Office Action Summary	Application No. 10/538,829	Applicant(s) GUSTAFSON, THOMAS F.	
	Examiner RYAN J. FRANKS	Art Unit 3633

DETAILED ACTION

3. Claims 1-6, 9-16, and 18-21 are rejected under 35 U.S.C. 102(b) as being anticipated by Mason (US Patent 1,830,518).

Fig. 1 from Mason

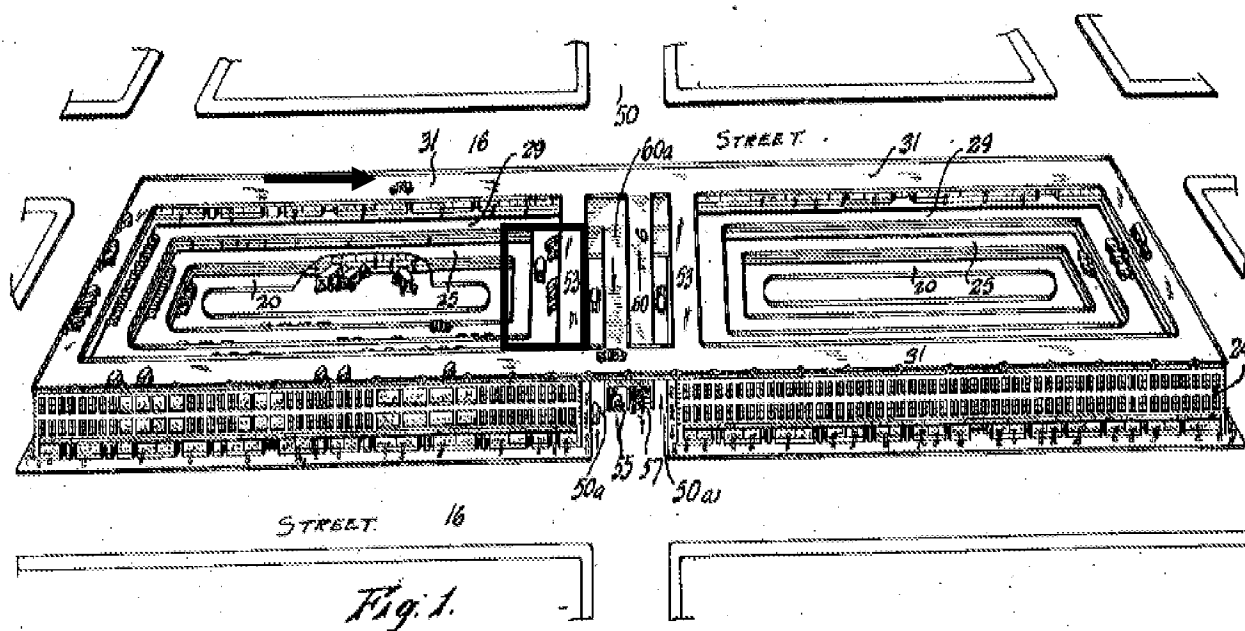
Regarding claim 1, Mason discloses a “mixed-use pedestrian parking structure (Fig. 1 in general) comprising:

- (a) at least two sequential multi-level parking units (Fig. 1, right and left buildings separated by intermediate street 50), each having one directional parking access aisle[s] (Fig. 1, element 25);
- (b) a liner building surrounding [the] parking units on at least one side of each of [the] sequential multi-level parking unit[s] (Fig. 2, elements 35, 18, 22, 27; page 4, lines 9-10 and 15-16); and
- (c) a multi-use buffer corridor (Fig. 2, element 36) defining an interface (Fig. 2, element 37) between [the] parking units (Fig. 2, element 25) and [the] liner building (Fig. 2, elements 35, [the] liner building including at least one common wall (interior wall 28) with [the] buffer corridor, [the] wall including means for access to and from [the] buffer corridor (page 4, line 67 defines names element 36 as a passageway; page 4 lines 39-42).”

Regarding claim 4, Mason discloses “an interior pedestrian corridor, transverse to [the] exterior corridor, [the] interior corridor substantially bisecting [the] at least two parking units (Fig. 1, portion of element 21 parallel with street 50).

Regarding claims 5 and 6, Mason discloses “a central atrium within at least one of [the] parking units (Fig. 1, right and left parking units have an open air atrium by nature of their inverted-pyramid design at the bottom of which lies parking/roadway 20).”

Regarding claim 11, Mason discloses a “mixed-use pedestrian parking structure (Fig. 1 in general) comprising:

(a) at least two multi-level parking units (Fig. 1, right and left buildings separated by intermediate street 50), each having one directional parking access aisle[s] (Fig. 1, element 25);

Regarding claim 14, "an interior pedestrian corridor, transverse to [the] exterior corridor, [the] interior corridor substantially bisecting [the] at least two parking units (Fig. 1, portion of element 21 parallel with street 50).

Regarding claim 15, Mason discloses "a central atrium provided within the parking units (Fig. 1, right and left parking units have an open air atrium by nature of their inverted-pyramid design at the bottom of which lies parking/roadway 20)."

Regarding claim 19, Mason discloses "a cross-over ramp between [the] sequential parking units" (Fig. 1, element 53/31 on top level)."

Fig. 2 from Mason

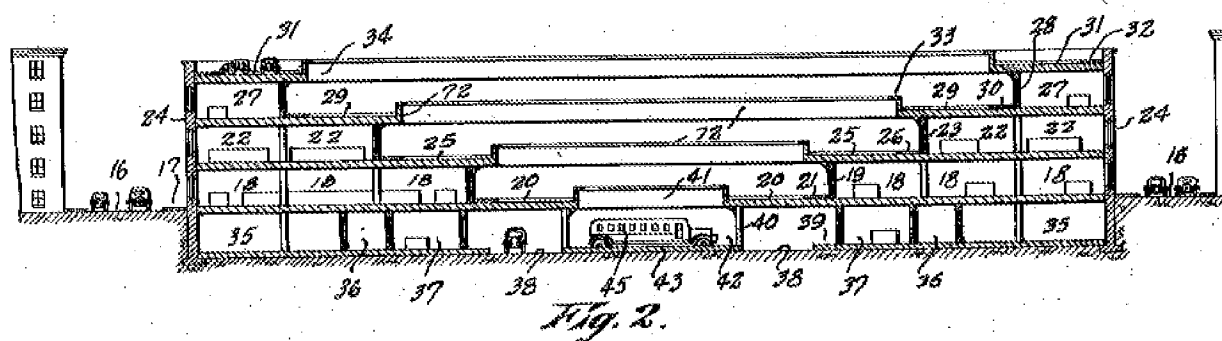
Regarding claim 2, Mason discloses “at least one exterior pedestrian-oriented corridor between at least one set of [the] sequential parking units (Fig. 2, element 32 around roadway/parking 31).”

Regarding claim 3, Mason discloses a “pedestrian-oriented....ground level corridor” (Fig. 2, element 17).

(b) a liner building surrounding [the] parking units on at least two sides of each parking unit (Fig. 2, elements 35, 18, 22, 27; page 4, lines 9-10 and 15-16), [the] liner building including at least one common wall with [the] parking units (Fig. 2, element 28), [the] wall including means for access to and from [the] inner building (column 4, lines 39-42)."

Regarding claim 12, Mason discloses "at least one exterior pedestrian-oriented corridor between at least one set of [the] sequential parking units (Fig. 2, element 32 around roadway/parking 31)."

Regarding claim 13, Mason discloses a "pedestrian-oriented....ground level corridor" (Fig. 2, element 17).

Regarding claim 16, Mason discloses "a multi-use buffer corridor (Fig. 2, element 36) defining an interface (Fig. 2, element 37) between [the] parking units (Fig. 2, element

25) and [the] liner building (Fig. 2, elements 35, [the] liner building including at least one common wall (interior wall 28) with [the] buffer corridor, [the] wall including means for access to and from [the] buffer corridor (page 4, line 67 defines names element 36 as a passageway; page 4 lines 39-42)."

Regarding claim 18, Mason discloses "at least one corridor contiguous with [the] at least one common wall" (Fig. 2, wall 28 is contiguous with corridor 36).
